<p>نگهداشت و افزایش تولید میدان نفتی بینک سطح الارض</p> <p>احداث ردیف تراکم گاز در ایستگاه جمع آوری بینک</p>																									
<p>شماره پیمان: ۰۵۳ - ۰۷۳ - ۹۱۸۴</p>

<table><tr> <th colspan="8">HAZOP REPORT FOR COMPRESSOR STATION</th> </tr><tr> <td>D00</td> <td>0004</td> <td>RT</td> <td>GE</td> <td>120</td> <td>PEDCO</td> <td>GCS</td> <td>BK</td> </tr></table>

The purpose of this document is to provide the results of “HAZOP Study” for **Binak Oilfield Development – Surface Facilities; New Gas Compressor Station**.

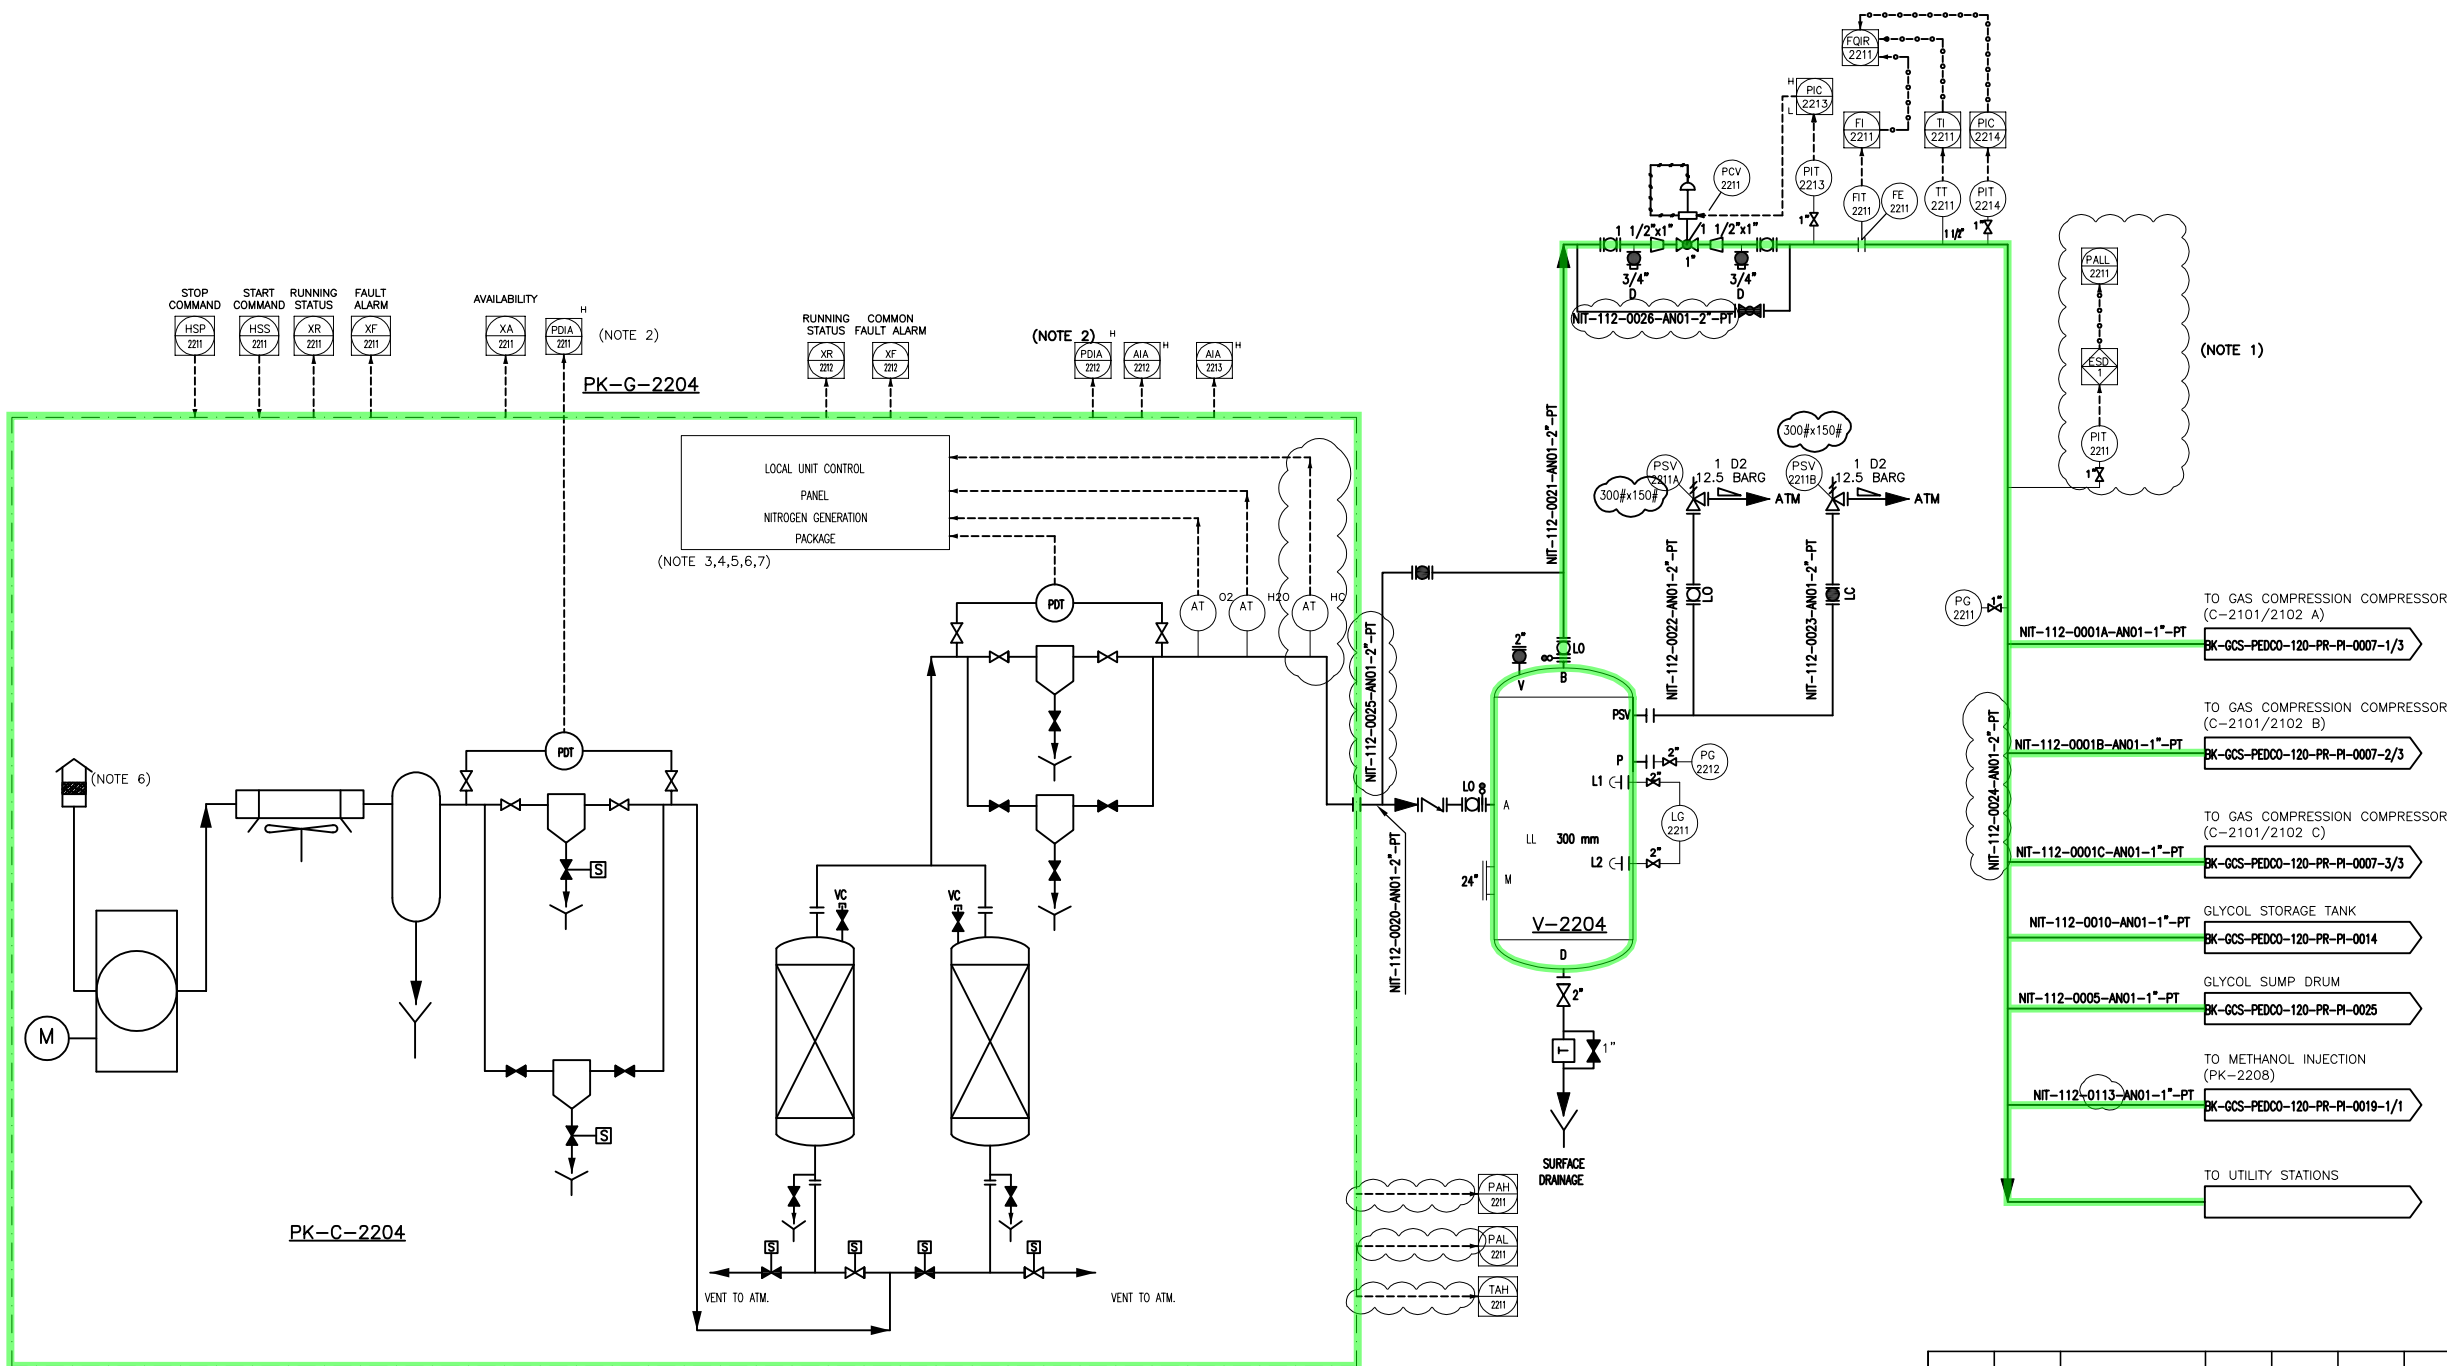
89. Remove mechanical trap from V-2204 and consider mechanical trap for wet air KO drum inside compressor package.	Consequences: 11.7.1.1	Contractor	Closed

90. Remove HC analyzer from nitrogen package.	Consequences: 11.8.1.1	Contractor	Closed
91. Consider check valve on 2" line from P-2201A/B to existing burn pit.	Consequences: 12.1.1.1	Contractor	Closed

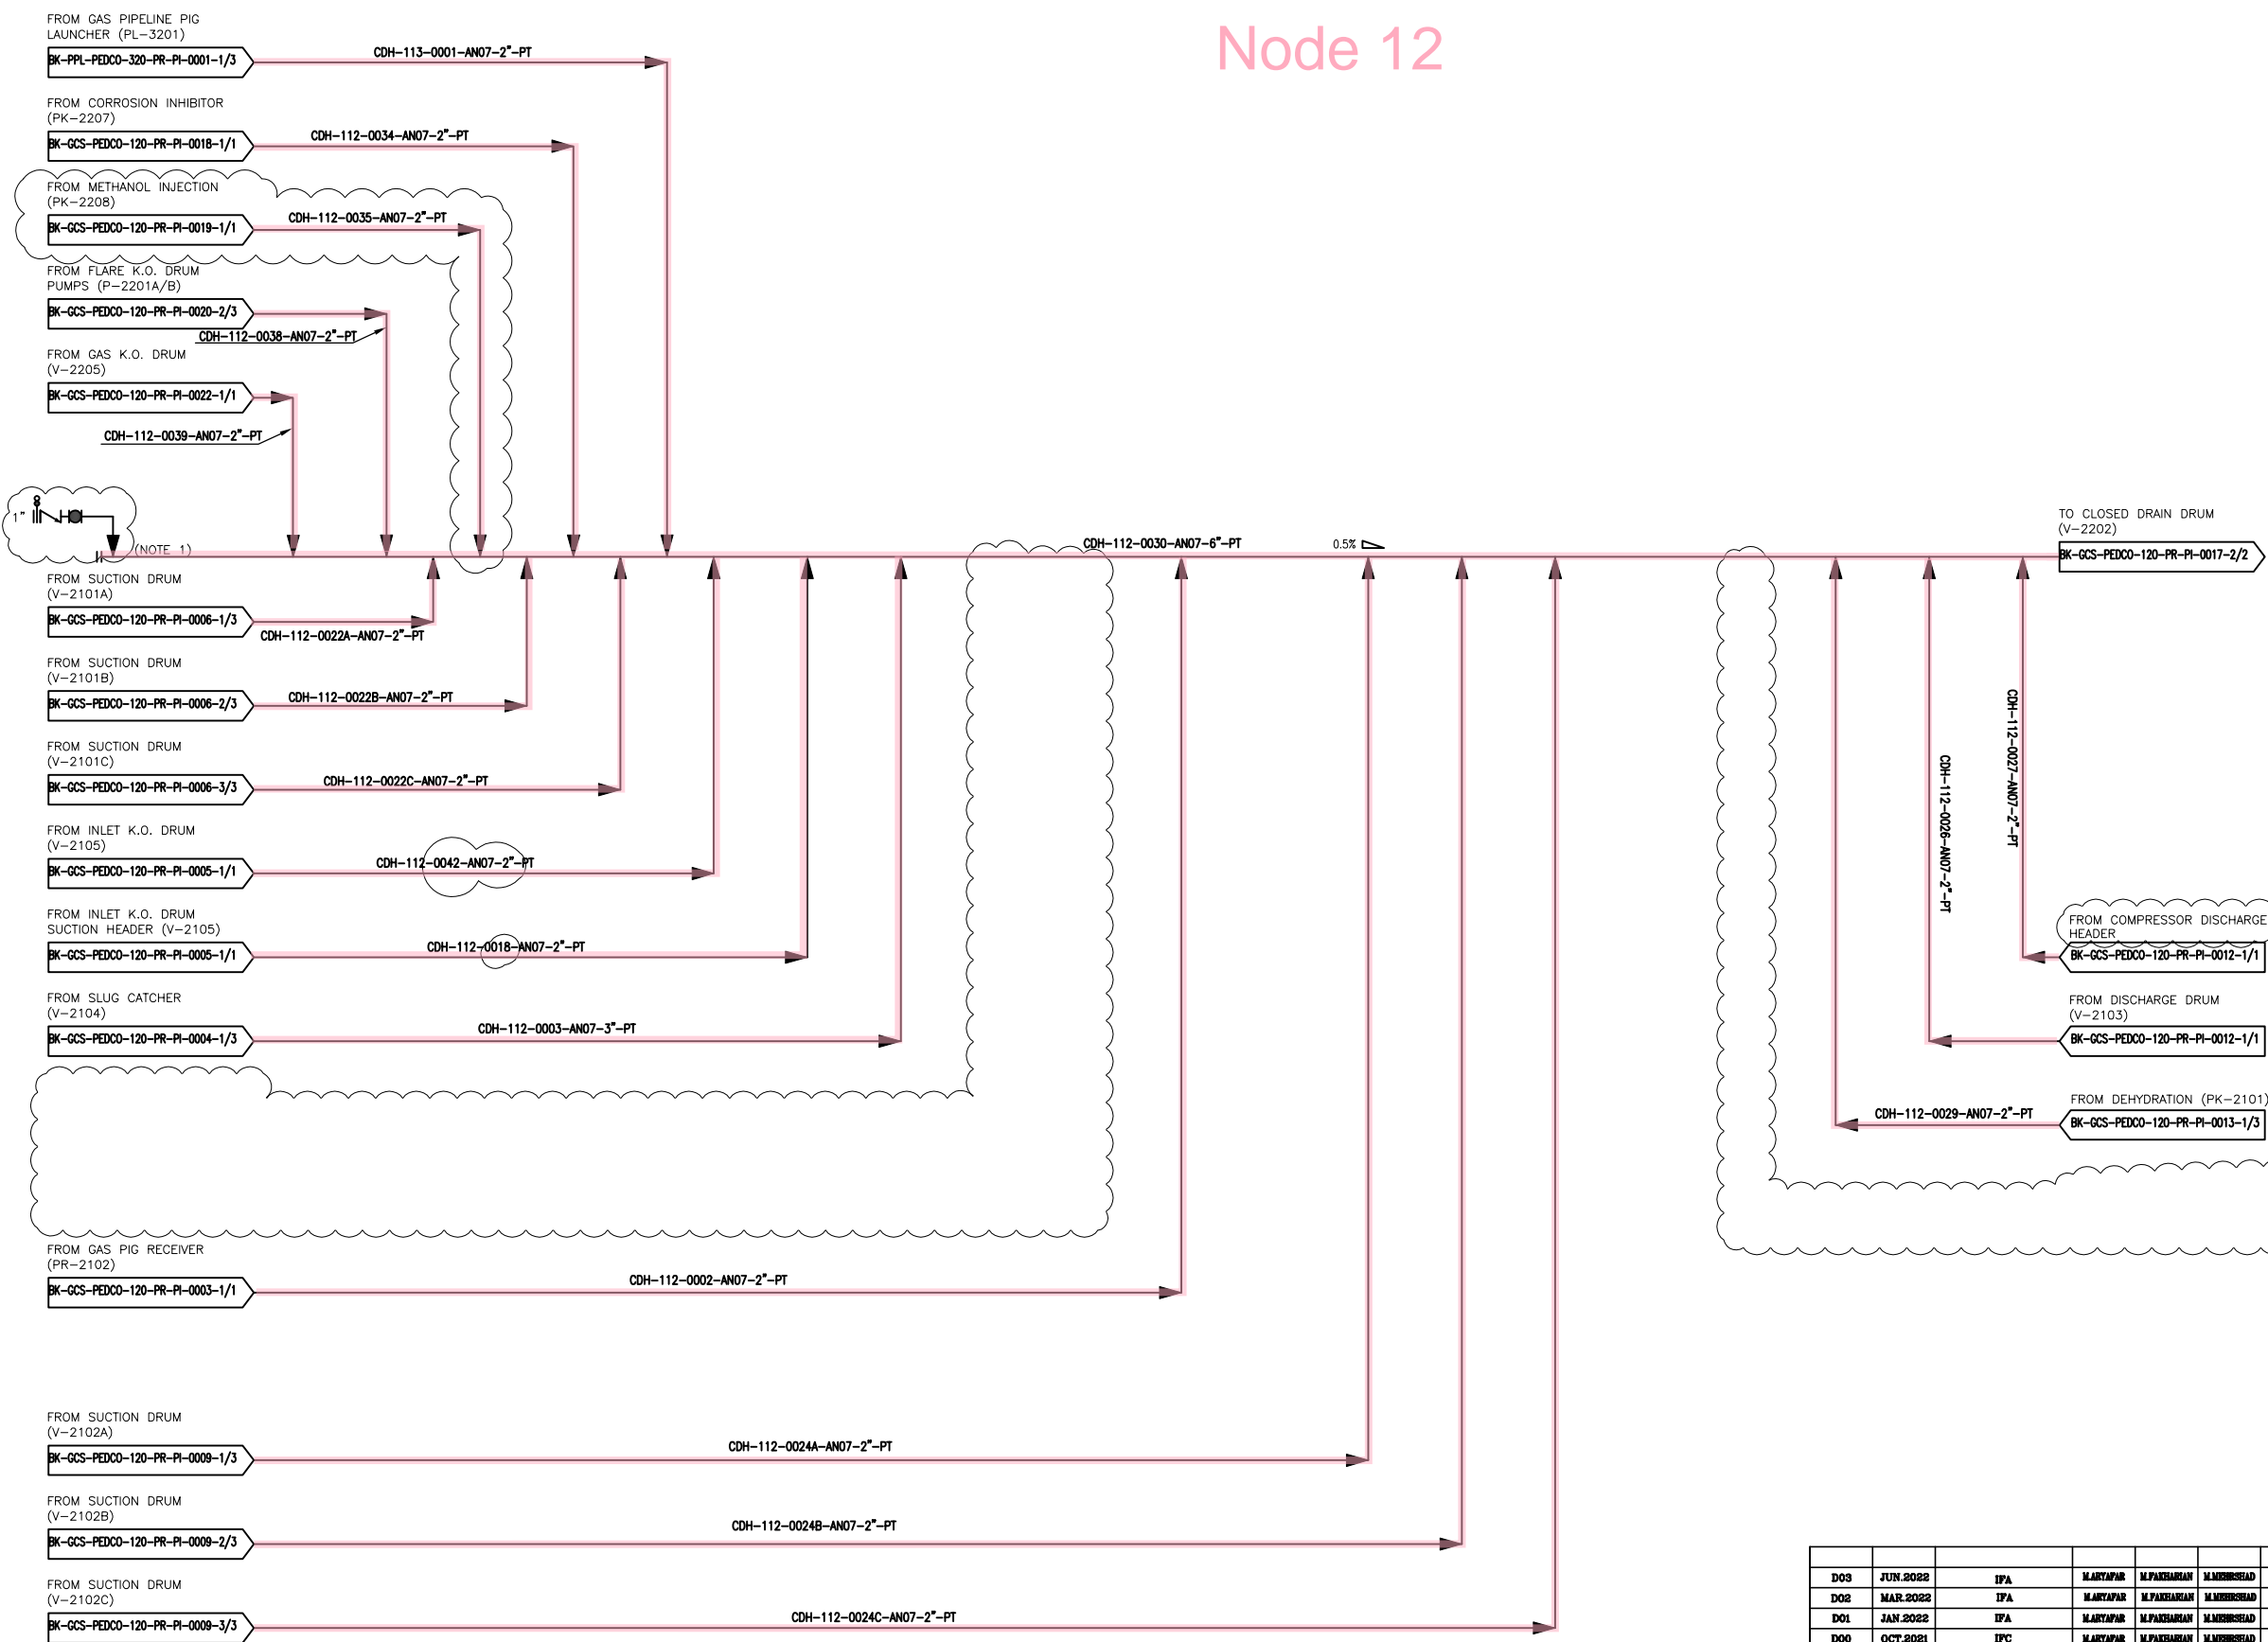
92. Remove 2" line connection from closed drain drum to oily	Consequences: 12.1.1.1	Contractor	Closed

V-2205
FUEL GAS K.O. DRUM

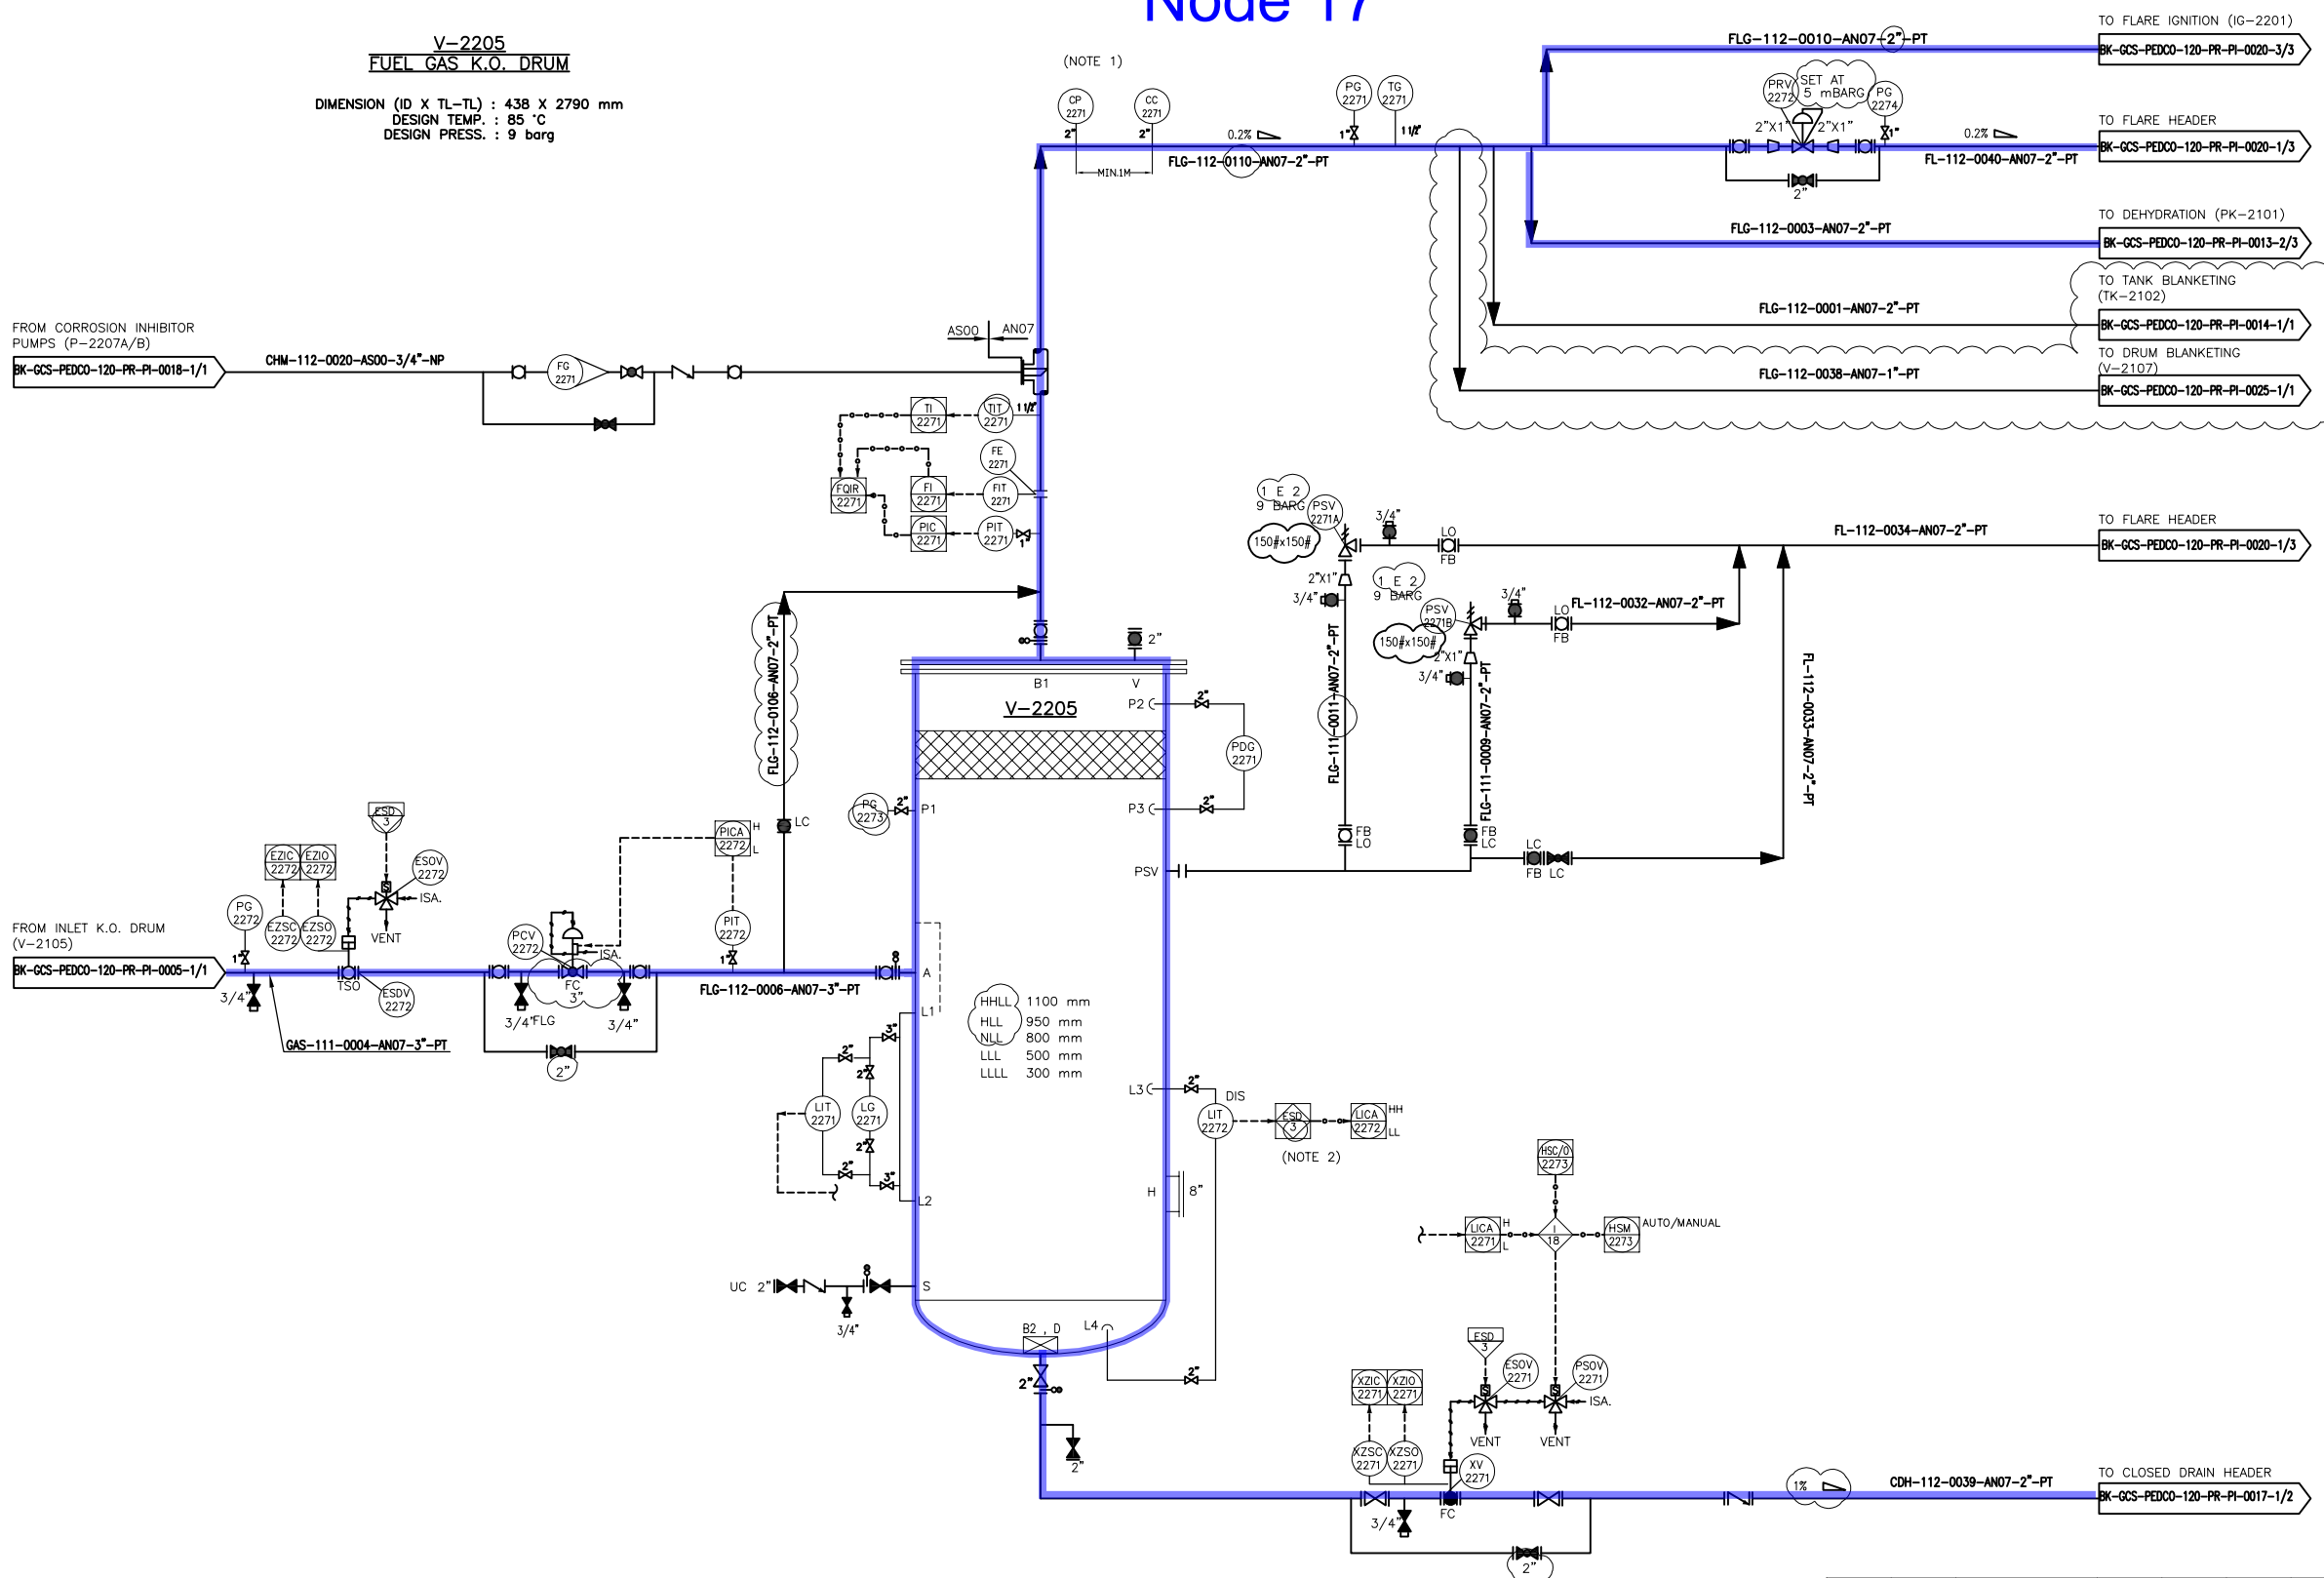
108. Replace PRV-2272 with local flow gauge, ball valve, check valve and globe valve.	Consequences: 17.1.3.1	Contractor	Closed
109. PSV on V-2205 should be sized for fire case.	Consequences: 17.4.1.1	Contractor	Closed

112. Remove fuel gas lines used for blanketing of TK-2102 and V-2107.	Consequences: 17.10.1.1	Contractor	Closed
113. Remove PT-2281A/B from suction of P-2206A/B and consider local pressure gauge.	Consequences: 18.1.3.1	Contractor	Closed
